DATE ~~R~~ Sep. 4/03**V2500-D5 SERIES NACELLE SERVICE BULLETIN**

This document transmits Revision 4 to Service Bulletin NV2500-78-0184

V2500-NAC-78-0184

NACELLE - EXHAUST - LANYARD, PRESSURE RELIEF DOOR, THRUST REVERSER - REPLACEMENT OF

Pressure Relief Door Lanyard Replacement
Figure 2 (sheet 4)

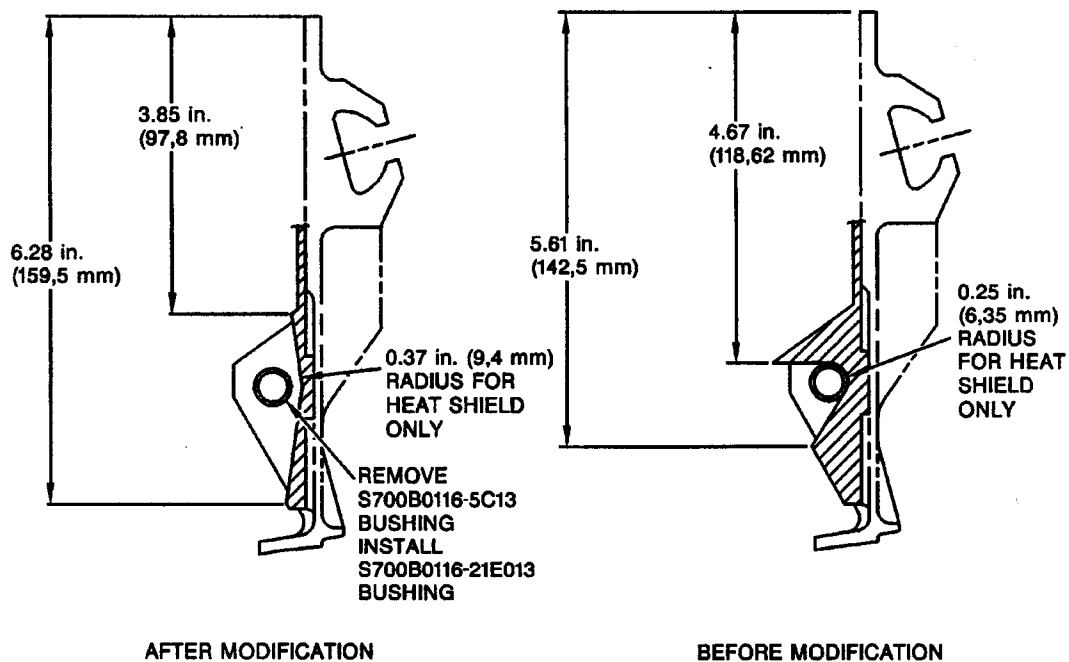
To update Sections 1.B.,
 1.E., 1.F., 1.K., and 2.B.,
 also to revise Fig.2 Sheets
 4 and 5.

- (1) Remove material from the heat shield to the dimensions shown in Figure 2 (sheets 4 and 5).
- (2) Clean the cut edges of the heat shield with a lint free cloth (CoMat 02-099) and solvent (CoMat 01-438).

Pressure Relief Door Lanyard Replacement
Figure 2 (sheet 5)

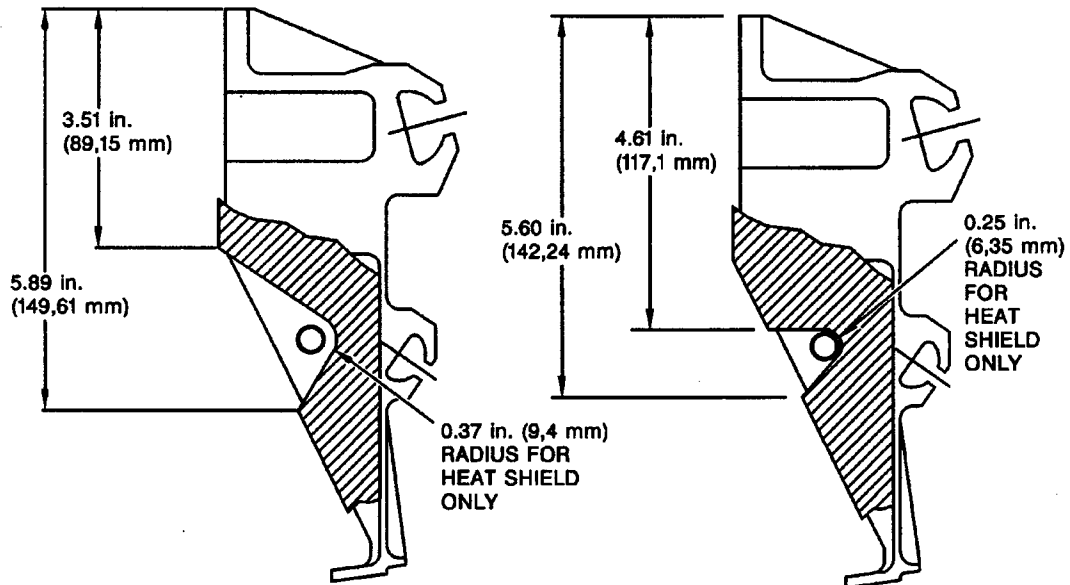
AFTER MODIFICATION

BEFORE MODIFICATION
